State Water Resources Control Board

03/27/2014
Mr. Jose Rodriquez
EMCO Wheaton Retail
1004 West Covina Parkway #413
West Covina, CA 91790

EVALUATION OF EQUIPMENT FOR EMCO WHEATON RETAIL ENHANCED VAPOR RECOVERY PHASE I SYSTEM

Typical Tank Vapor Riser Installation for Direct Burial Configuration

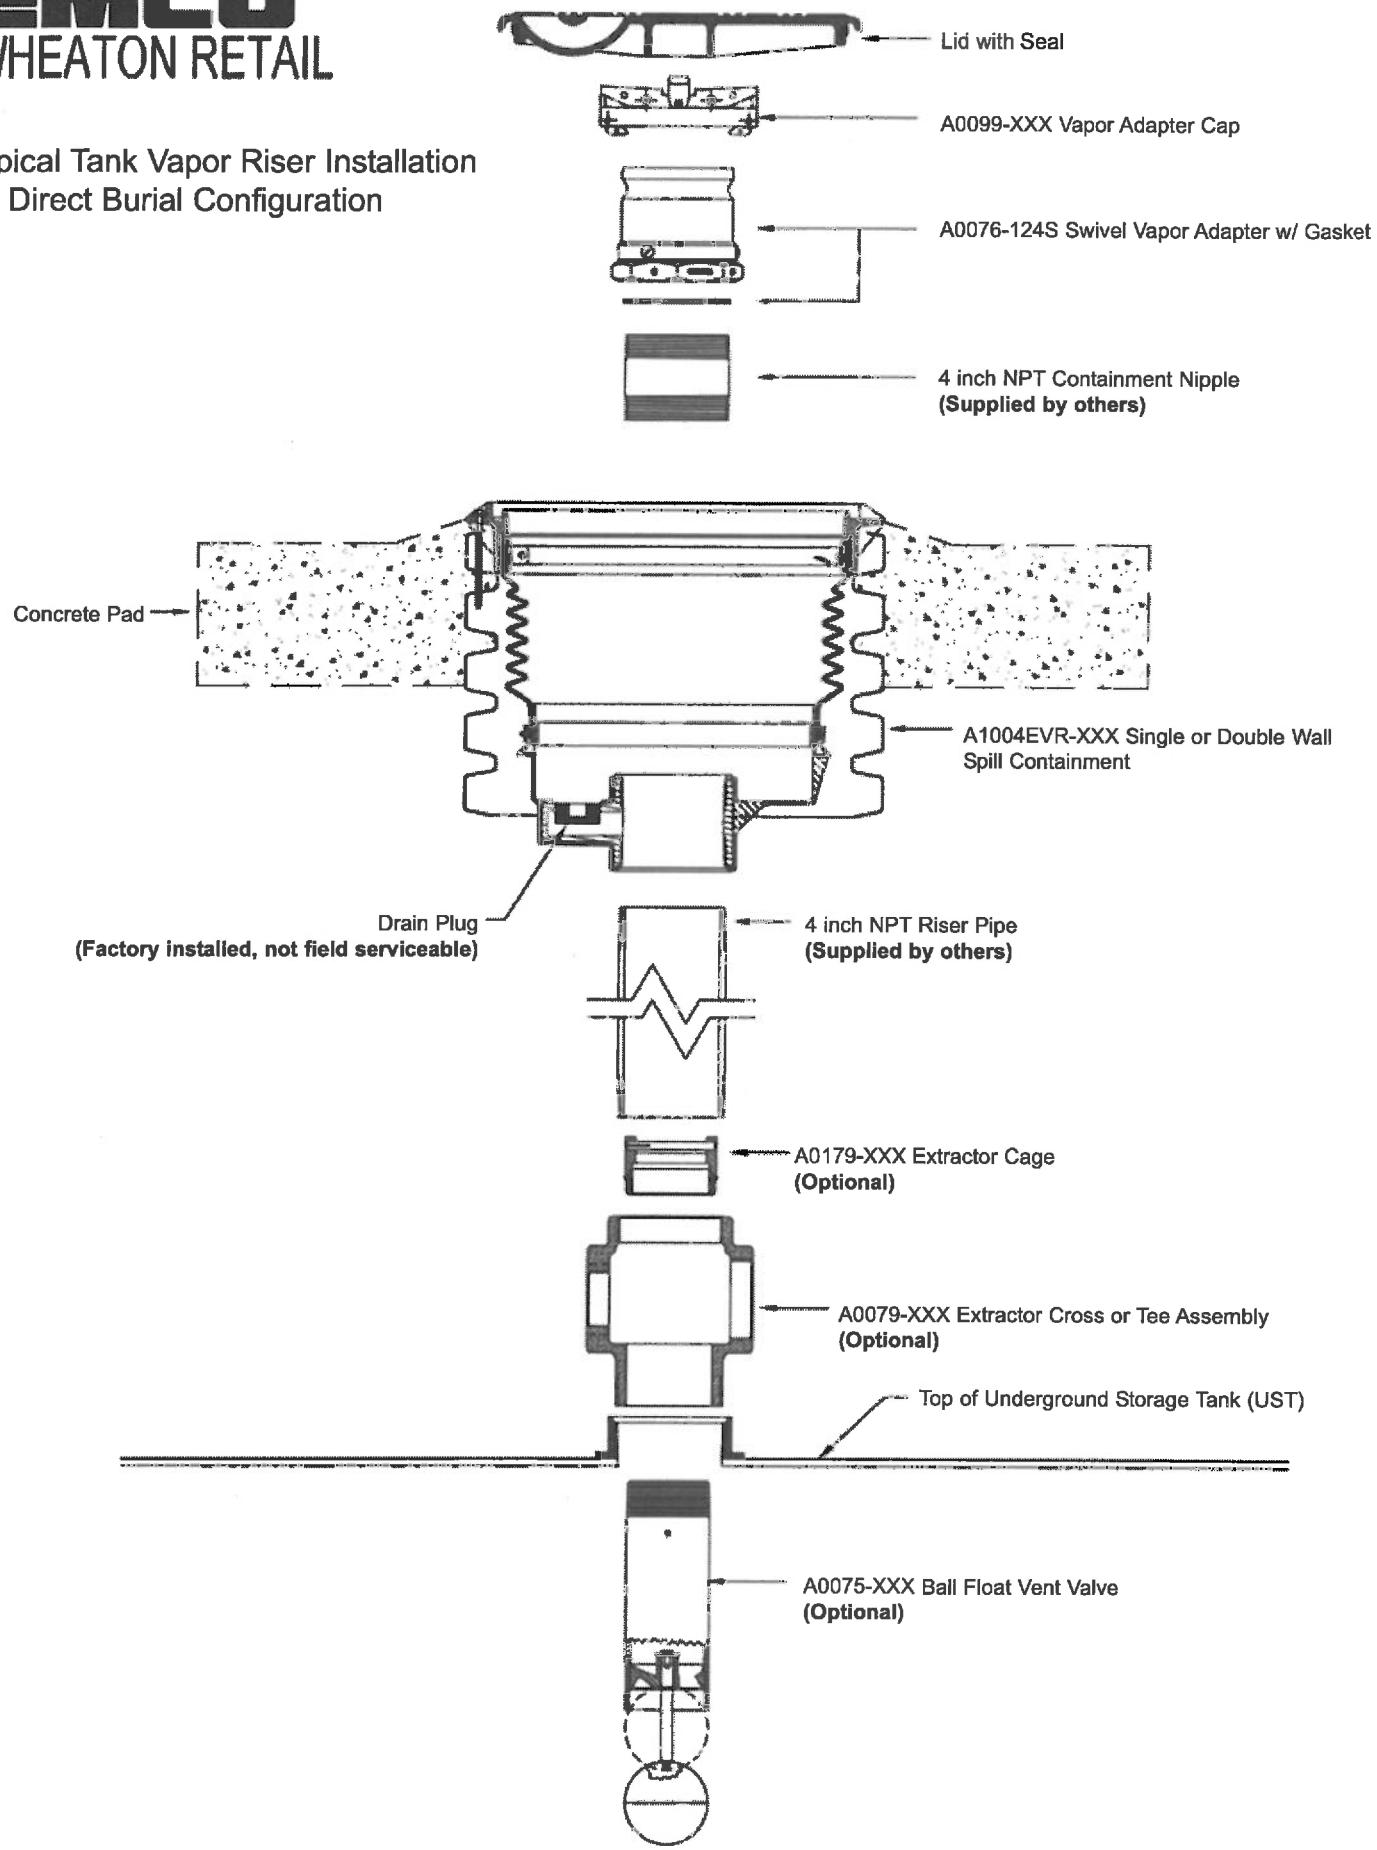
2. The direct burial configuration of this system does not provide secondary containment for the tank fill riser. Secondary containment of the tank fill riser is required on all UST systems installed on or after July 1, 2003 and on certain other UST systems pursuant to chapter 6.7 of the Health and Safety Code and implementing regulations. Accordingly, the direct burial configuration can only be used on UST systems where secondary containment of the fill riser is not required.
